# CITY OF CLARKSBURG SANITARY BOARD HARRISON COUNTY, WEST VIRGINIA

#### MILFORD AREA UPGRADES

#### **ADDENDUM #2**

#### THRASHER PROJECT #T20-11053

CLARKSBURG SANITARY BOARD
MILFORD AREA
UPGRADES PROJECT
HARRISON COUNTY, WEST VIRGINIA
PROFILE SHEET

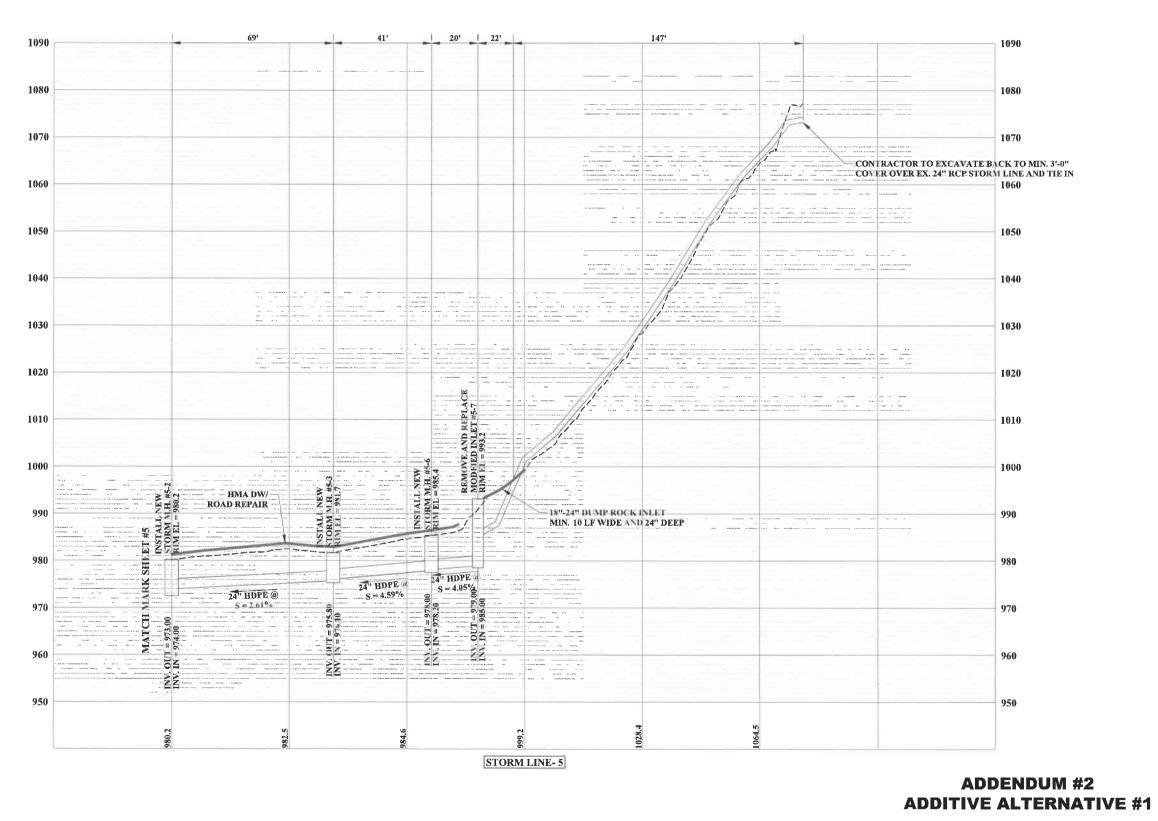
- 1. Revised Index Revised to reflect new plan sheets.
- 2. Revised Sheets 4&4A Revised Method of Installation. Base Bid (Sheet 4 & 4A) and Deductive Alternate #1.
  - a. Easement will be provided at top of hill for pull-back.
- 3. Sheets 5&5A Additive Bid Alternate #1.
- 4. Sheets 6&6A Additive Bid Alternate #2.

On Plan Sheet 4, it shows both a Jack & Bore and an HDD, with different footage for each. Which is it?

If the Route 19 crossing shown on Sheet 4 is a 48-inch Jack & Bore, what are the additional insurance requirements necessary for tunnelling with that diameter of pipe?

This sheet has been revised. Plan Sheets 4 & 4A depict a HDD, which shall be part of the Base Bid. The Contractor shall also provide alternate prices for the work shown on Plan Sheets 5, 5A, 6, and 6A. Please see the revised and added Plan Sheets and the revised bid form included with this Addendum. YOU MUST USE THE REVISED BID FORM WHEN PREPARING YOUR BID PACKAGE FOR THIS PROJECT.

Jack & Bore installation previously shown on Sheet #4 has been corrected to 36-inch steel on added Plan Sheets 5, 5A, 6 and 6A. All insurance requirements for this project are described in the Supplementary General Conditions of the Contract Documents.

CLARKSBURG SANITARY BOARD
MILFORD AREA
UPGRADES PROJECT
HARRISON COUNTY, WEST VIRGINIA
PROFILE SHEET

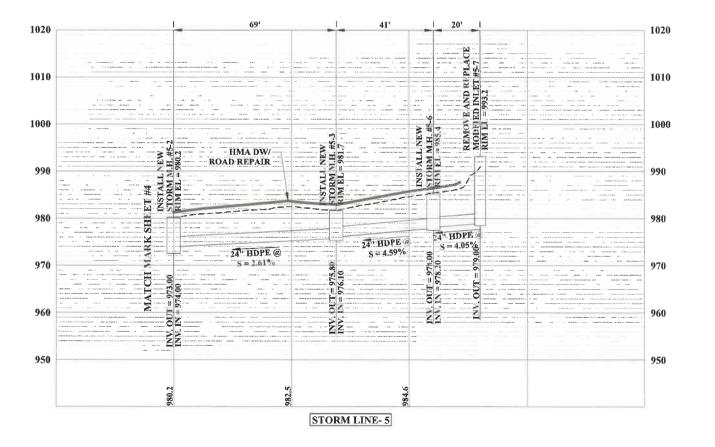
# ADDENDUM #2 ADDITIVE ALTERNATIVE #2
